Access Compliance Report

Public Rights-of-Way

(Curb Ramps)

Intersection ID: 27942	Main Street: COMMUNITY_HOUSE_RD	Cross Street: NORTH_COMMUNITY_HOUSE_RD	Location: SW
ADA ID: 05794C8AC798	Ramp Type: BlendTrans1	Initial Pass/Fail: Pass	Overall Compliance: No
		Severity Score: 0.25

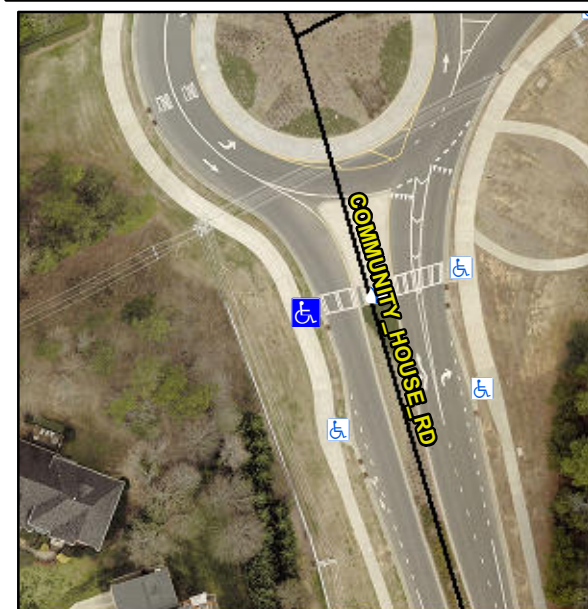
R304.5.3, R305.2

Compliance	Description	Data	Compliance	Description	Data
N/A	Ramp Length (in)	72.0	Yes	BlendTrans Slope (%)	1.0
Yes	Ramp Width (in)	116.0	No	BlendTrans XSlope (%)	4.3
Yes	Flare Type L	Curbed_NoWalkSurface	Yes	Flare Type R	Curbed_NoWalkSurface
N/A	Flare Slope LT (%)	N/A	N/A	Flare Slope RT (%)	N/A
N/A	Flare Traversable LT?	No	N/A	Flare Traversable RT?	No
Yes	Landing Length (in)	120.0	Yes	DWS Provided?	Yes
Yes	Landing Width (in)	116.0	Yes	DWS Contrast?	Yes
Yes	Landing Slope (%)	1.2	Yes	DWS Length (in)	24.0
Yes	Landing X Slope (%)	1.8	Yes	DWS Full Width?	Yes
N/A	Landing Curb? (Y/N)	No	No	DWS Offset (in)	3.0
N/A	Shared Landing?	No			
Yes	Gutter Ponding?	No	Yes	Gutter Slope (%)	1.1
Yes	Gutter Lip Ht (in)	0.0	Yes	Gutter X Slope (%)	1.6
N/A	Painted X Walk1?	Yes	N/A	Painted X Walk2?	N/A
	X Walk 1 Direction	To NE		X Walk 2 Direction	N/A
	X Walk 1 Width (in)	109.0		X Walk 2 Width (in)	N/A
	X Walk 1 Slope (%)	2.5		X Walk 2 Slope (%)	N/A

Remove & Replace Curb Ramp With Two New Directional Ramps or Equivalent.
